Access Compliance Report

Public Rights-of-Way

Intersection ID: 24474	Main Street: DARNLEY_PL	Cross Street: SEQUOIA_RED_LN	Location: SW
ADA ID: B9384752BC99	Ramp Type: PerpDiag	Initial Pass/Fail: Fail	Overall Compliance: No
Severity Score: 12.5			
Codes/Mitigation Info/Possible Solution		Field Measurements/Component Compliance

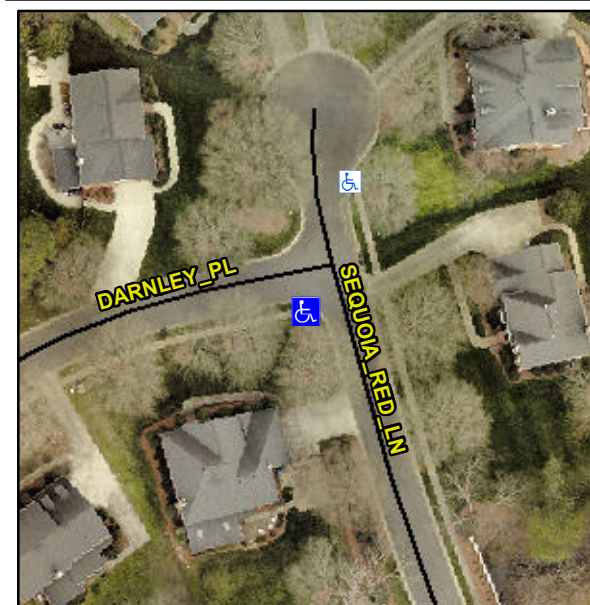
Not Found, R304.5.3

Compliance	Description	Data	Compliance	Description	Data
N/A	Ramp Length (in)	25.0	Yes	Ramp Slope (%)	5.2
Yes	Ramp Width (in)	48.0	No	Ramp XSlope (%)	5.1
N/A	Flare Type LT	N/A	N/A	Flare Type RT	N/A
N/A	Flare Slope LT (%)	N/A	N/A	Flare Slope RT (%)	N/A
N/A	Flare Traversable LT?	N/A	N/A	Flare Traversable RT?	N/A
N/A	Landing Length (in)	N/A	N/A	DWS Provided?	N/A
N/A	Landing Width (in)	N/A	N/A	DWS Contrast?	N/A
N/A	Landing Slope (%)	N/A	N/A	DWS Length (in)	N/A
N/A	Landing X Slope (%)	N/A	N/A	DWS Full Width?	N/A
N/A	Landing Curb? (Y/N)	N/A	N/A	DWS Offset (in)	N/A
N/A	Shared Landing?	N/A			
N/A	Gutter Ponding?	N/A	N/A	Gutter Slope (%)	N/A
N/A	Gutter Lip Ht (in)	N/A	N/A	Gutter X Slope (%)	N/A
N/A	Painted X Walk1?	No	N/A	Painted X Walk2?	No
	X Walk 1 Direction	To E		X Walk 2 Direction	To N
N/A	X Walk 1 Width (in)	N/A	N/A	X Walk 2 Width (in)	N/A
	X Walk 1 Slope (%)	5.1		X Walk 2 Slope (%)	1.1
	X Walk 1 X Slope (%)	0.1		X Walk 2 X Slope (%)	4.1

Remove & Replace Curb Ramp With Two New Directional Ramps or Equivalent.
